N2831A-02

# Modification Recommended Service Note

N2831A 8 GHz InfiniiMax III+ Series Probe Amplifier  
Serial Numbers: ALL

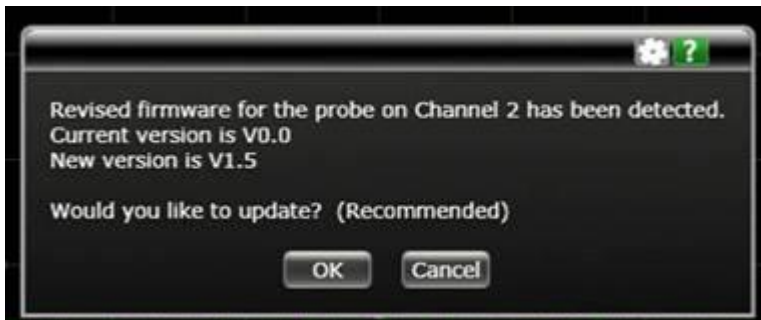
1. Ask the customer if he/she has seen the following message when plugging his/her probe onto an oscilloscope:

2. Regardless of the customer's answer to the question, plug the customer's probe onto a Service Center scope with software version 06.20.00701 or later.
3. If the Customer said No in step 1 or was unsure: tell the customer that Keysight recommends downloading latest scope software version—Version 06.20.00701 or later. Continue with standard procedure.
4. If the Customer said Yes, the probe appears to function normally on the scope, and it passes calibration, the probe has been fixed. Send the original probe back to the customer, and tell the customer that Keysight recommends an upgrade to oscilloscope software—Version 06.20.00701 or later to prevent this issue from re-occurring to their probe.
